**STATE OF TENNESSEE  
DEPARTMENT OF TRANSPORTATION  
ROADWAY DESIGN DIVISION**

**INSTRUCTIONAL BULLETIN NO. 14-08**

**Regarding Revised Standard Drawings**

**Effective for the February 2015 Letting (Dec 3rd turn-in)**, the following Standard Drawings are revised or new. Section V of the Guidelines is also revised effective that date. Standard Drawings **T-S-16A** is voided by this Instructional Bulletin.

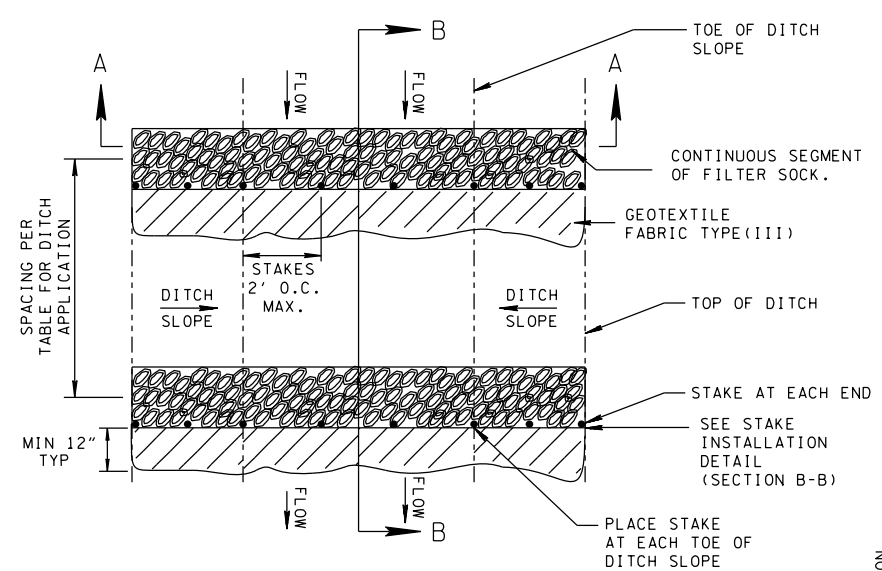
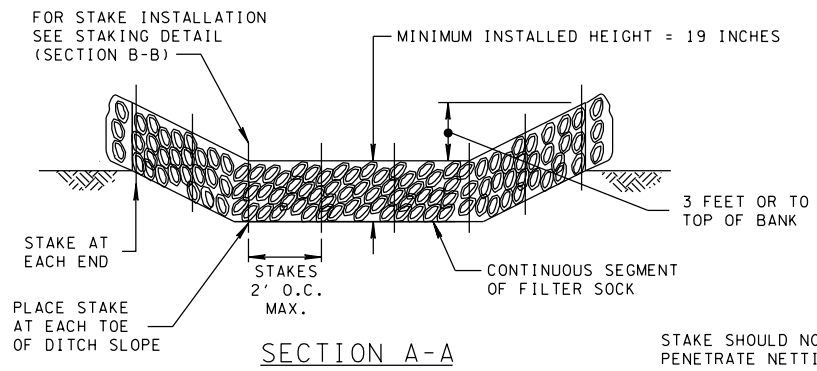
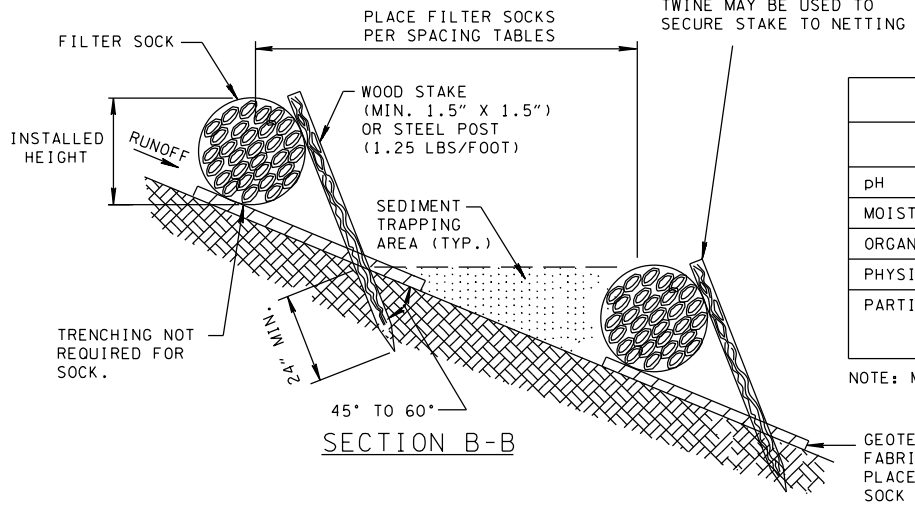
REV. 8-1-12: MINOR EDITS TO GENERAL NOTES.  
 REV. 6-10-14: MODIFIED SPACING TABLE. ADDED GEOTEXTILE FABRIC ADDED NOTE (N)
